SERVICE BULLETIN

MD-80/90 SERIES

COMMUNICATIONS, PASSENGER ADDRESS SERVICE INTERPHONE CALL SYSTEM (PASICS), ELECTRONIC SWITCHING UNIT P/N 686-3000-002; MODIFICATION FOR PA CH#1 GAIN ADJUSTMENT CAPABILITY AND POWER DELIVERY TO AFT/MID HANDSETS.

686-3000-23-3

ESU ASSEMBLY, BASIC P/N 686-3000
FIGURE 1

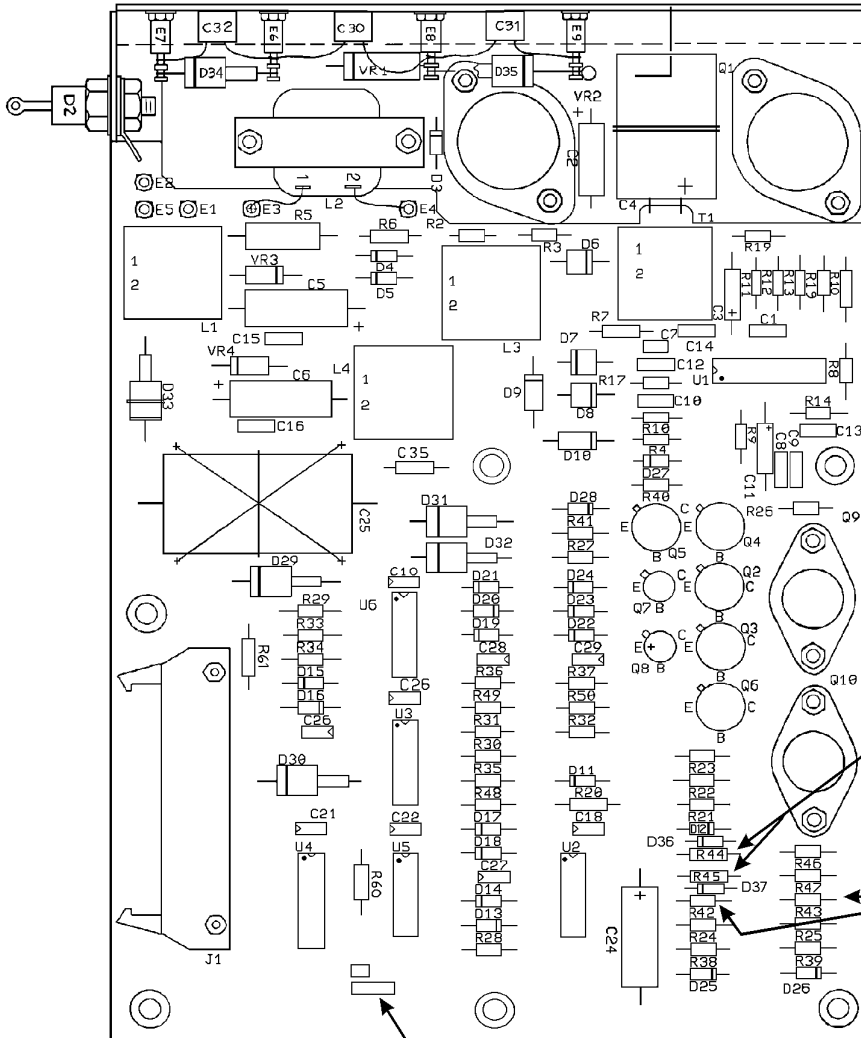
A. Disassembly: Item references are per Figure 1 of this bulletin.

- (1) Remove cover (2) by removing ten each pan head screws (9) and flat washers (11).
- (2) Remove three each pan head screws (8) and flat washers (11) which secure A2 card assembly (3) to side of chassis (1).
- (3) Release retainers and disconnect electrical harness (5) from connector receptacles of A2 and A1 circuit card assemblies (3 & 4).
- (4) Remove six each pan head screws (10), lock washers (12) and flat washers (11). Remove A2 card assembly and set aside in an ESD protective container.
- (5) Remove three each pan head screws (8), and flat washers (11), that secure A1 card bracket to chassis.
- (6) Remove A1 card assembly (4) from chassis (1). Ensure that isolator washers (13) remain adhered to bottom of card.

FIGURE 2

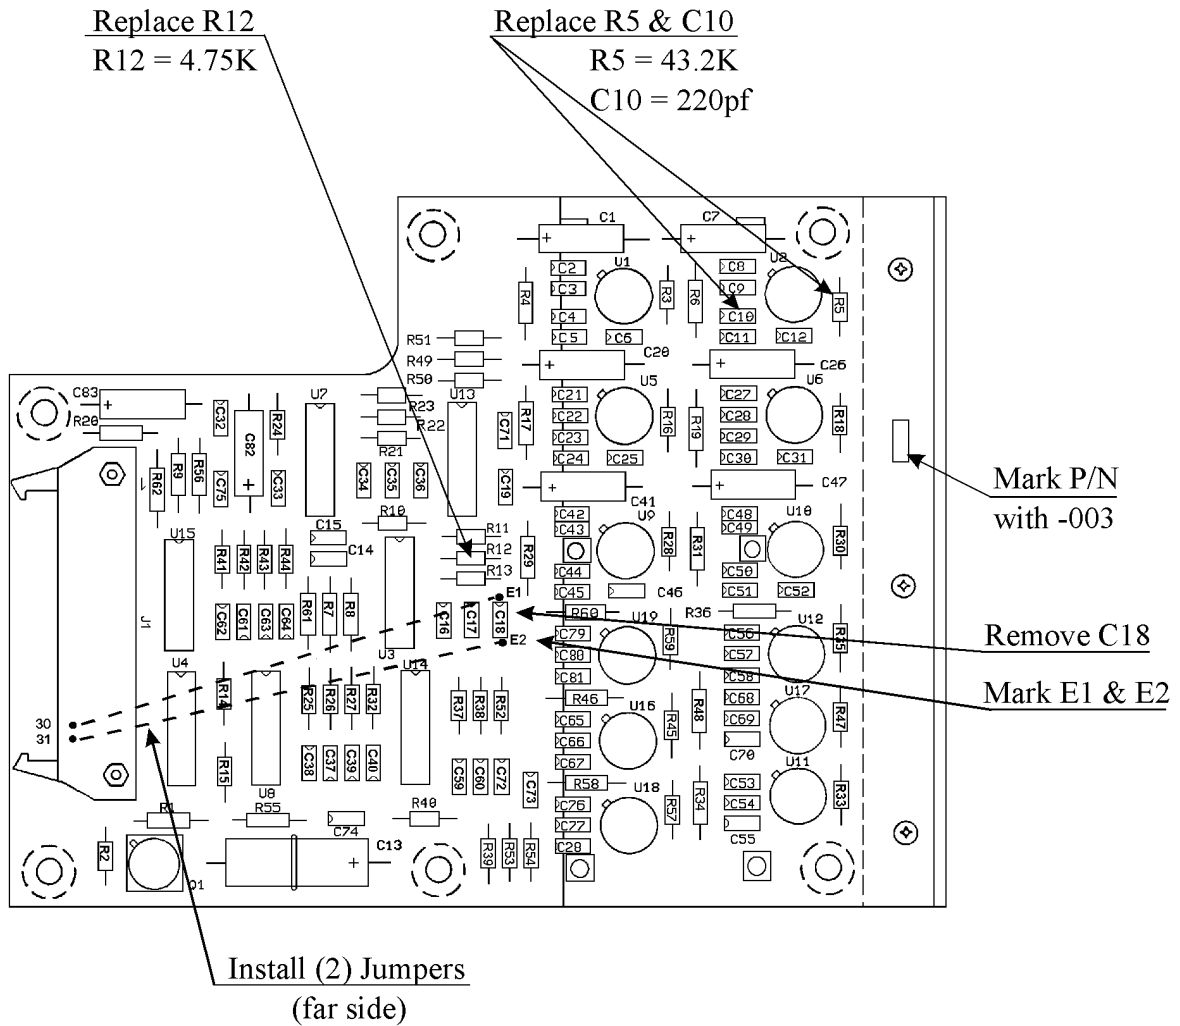
- (1) Desolder and remove resistors R42, R43, R44 and R45 from A1 card assembly. Refer to Figure 2 of this bulletin for locations.
- (2) Install and solder a 3.16K Ω , 1.5W, 1% resistors (P/N RWR80S3161FS) in the R42 positions and a 2.0K Ω , 1.5W, 1% resistor (P/N RWR80S2001FS) in the R43 position. Since these components are longer in length than the original resistors, a service loop must be incorporated in each leg of the component (refer to Figure 2).
- (3) Install and solder a 4.32 Ω , 1W, 1% resistor (P/N RWR81S4R32FS) in R44 position and a 2.00 Ω , 1W, 1% resistor (P/N RWR81S2R00FS) in R45 position of the A1 card assembly. In the case of a -003 or -004 card assembly, these resistors will be mounted on turret terminals along with a diode, -005 card assembly resistor mounting is in plated thru holes. Clip excess lead length on DIP side of card.

Replace R44 & R45
R44 = 4.32 Ohm, 1W
R45 = 2.0 Ohm, 1W

Replace R42 & R43
R42 = 3.16K, 1.5W
R43 = 2.0K, 1.5W

Mounting Method
for R42 & R43

Mark New Dash Number

From -003 to -006

-004 to -007

-005 to -008

AUDIO CARD ASSEMBLY (A2) - P/N 686-3020-002
COMPONENT LOCATION & MODIFICATION
FIGURE 3

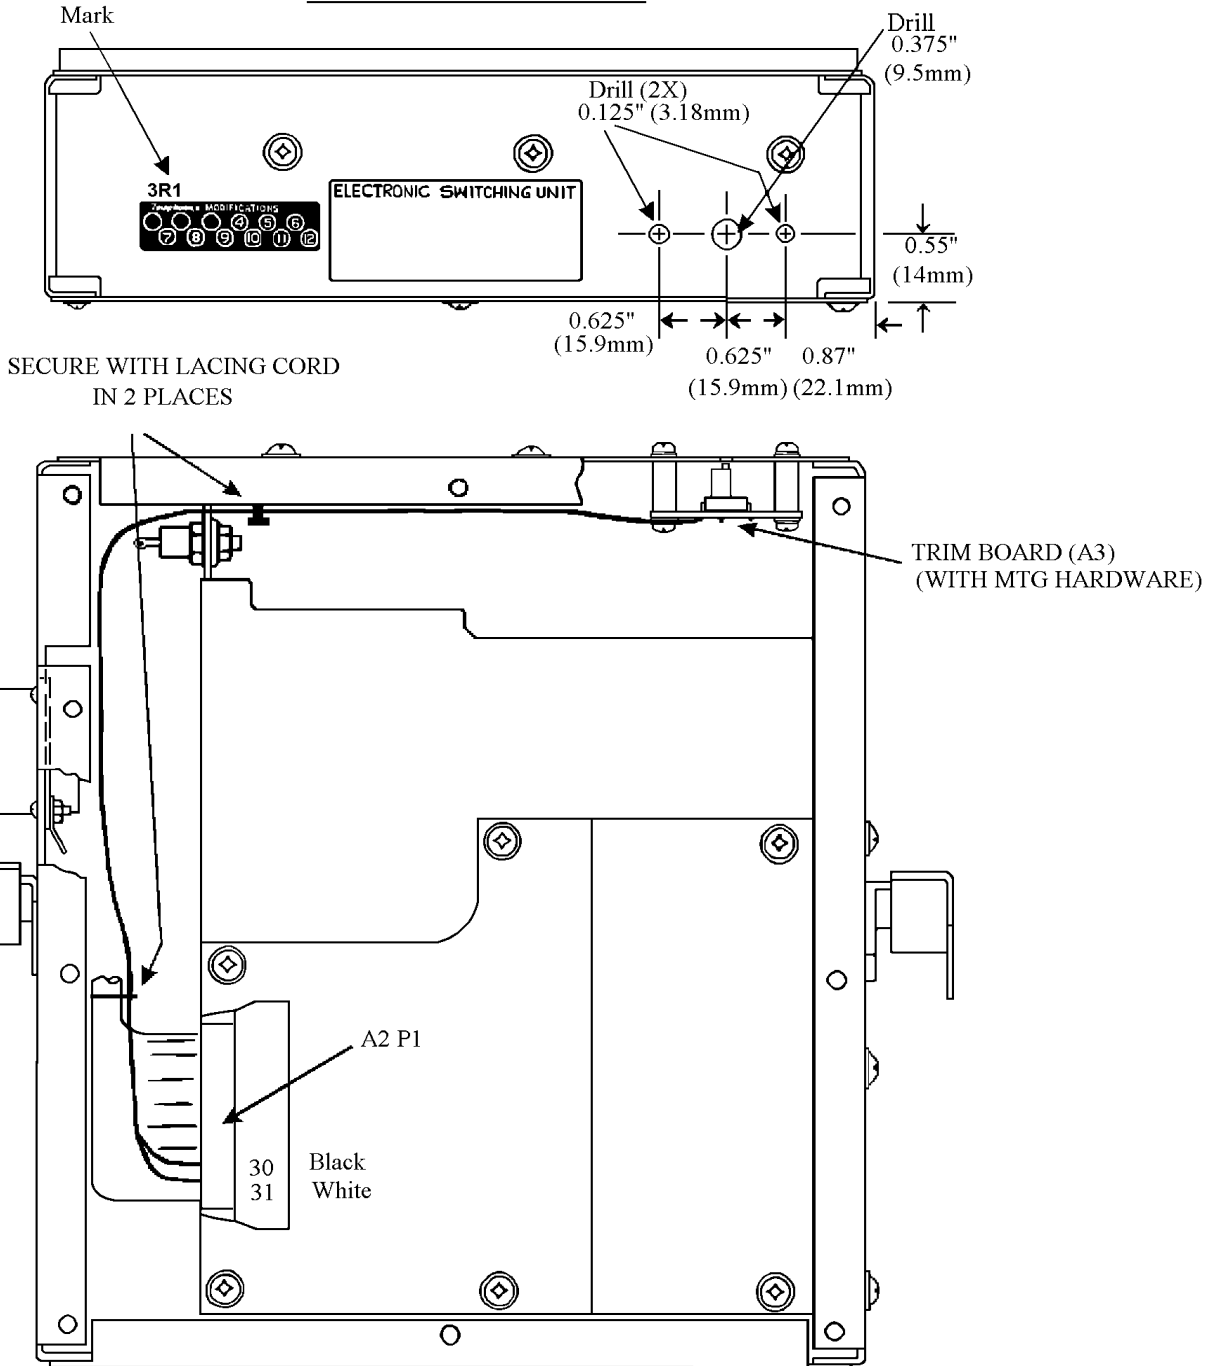
- (6) On A2 card assembly, desolder and remove C10, C18, R5 and R12, refer to Figure 3 of this bulletin for locations.
- (7) Install and solder a 220pf, 100V, 10% capacitor (P/N M39014/22-0987) in C10 location, a 43.2K Ω , 1/8W, 1% resistor (P/N RLR05C4322FM) in R5 location and a 4.75K Ω , 1/8W, 1% resistor (P/N RLR05C4751FM) in R12 location.

- (8) Using #26 AWG insulated jumper wire, install two jumpers on the DIP side of the A2 card assembly as shown in Figure 3. One jumper from J1-30 to the open C18 pad designated E1 and the second from P1-31 to the other open C18 pad designated E2. Secure the jumpers, at their mid points, using small quantity of quick-setting epoxy.

- (11) On A2 card assembly, obliterate the C18 marking and mark E1 and E2, using white epoxy ink, as shown in Figure 3.
- (12) Identify incorporation of modification on card assembly by marking new dash number, using white epoxy ink, of the A1 & A2 circuit cards Part Number as follows;
A1 card P/N 686-3023-003 remark as -006 Rev. T,
686-3023-004 remark as -007 Rev. T,
686-3023-005 remark as -008 Rev. T

MODIFIED ESU CHASSIS ASSEMBLY
FIGURE 4

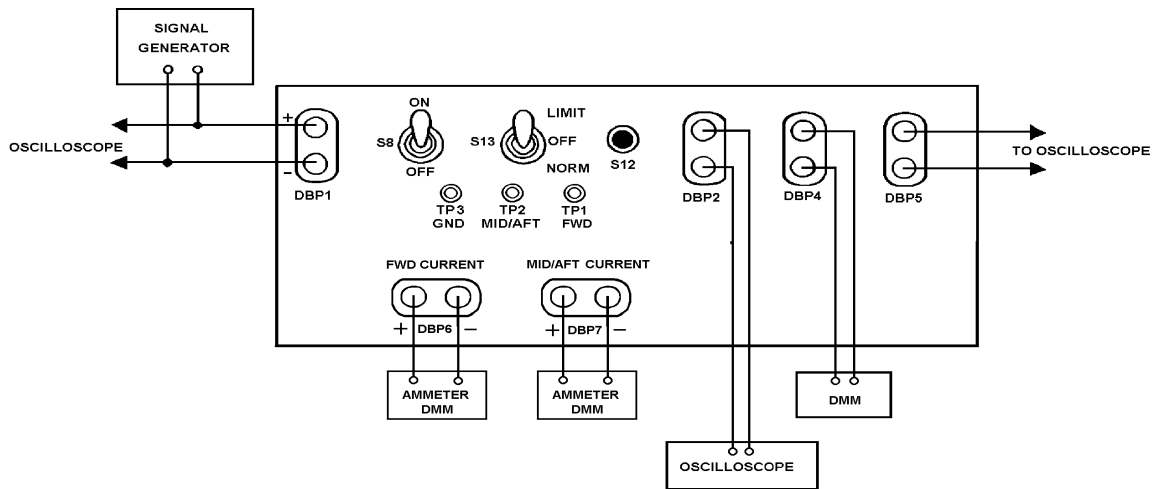
A2 card P/N 686-3020-002 remark as -003 Rev. -
- (13) Set A1 and A2 card aside in ESD protective containers and proceed with chassis modifications.
- (14) On chassis side, to right of ID plate, locate and mark drilling holes as shown in Figure 4. Drill two (2) 0.125 in. (3.18mm) holes and one (1) 0.375 in. (9.5mm) hole, as shown in Figure 4. Debur holes and ensure loose metal shavings are cleaned from inside unit.

- (15) Mount Trim board assembly A3 (P/N 686-0015-001), using two each pan head screws, lock washer and flat washer, (supplied with assembly) as shown in Figure 4.
- (16) Route white and black wires from trim board assembly along inner edge of chassis proceeding towards the harness connector A2J1. At the A2J1 connector, carefully remove both cover halves, starting with the top half. Remove unused pins #30 & 31 by depressing small tang on pin, accessible thru opening in body of connector, with a dental pick, and pulling pin out rear of connector with needle-nosed pliers.
- (17) Insert white and black wire pins into A2J1 locations 31 & 30 respectively, making sure that pins are seated fully and locked in place. Reinstall both connector cover halves, bottom side first. Using lacing cord, secure white and black wires to wire harness and to E7 terminal on the A1 card as shown in Figure 4.

- (a) If not already installed, mount adhesive-backed modification record plate P/N 255B012 (7) one quarter inch to left of ID plate (6).
- (b) Using black epoxy ink, obliterate circled numeral ③ of the plate (7), and hand stamp “3R1” on the chassis metal above the modification record plate, as shown in Figure 4.
- (c) Remove existing ID plate (6), clean any remaining adhesive residue and install new adhesive backed ID Plate in same location.

SCHEMATIC DIAGRAM CHANGES

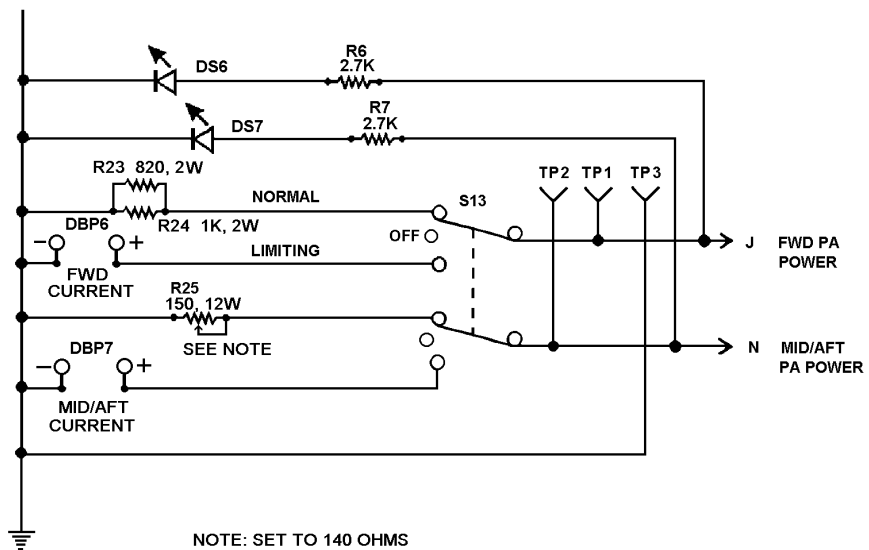
Modification to the test fixture includes the addition of one toggle switch, three resistors, three test point terminals and two binding posts. Depicted below is the lower section of the tester front panel showing switch S13, terminals TP1, TP2 & TP3 and DBP6 & DBP7 binding posts. A parts list and a revised schematic are also provided.

Change drawing area

From:

To:
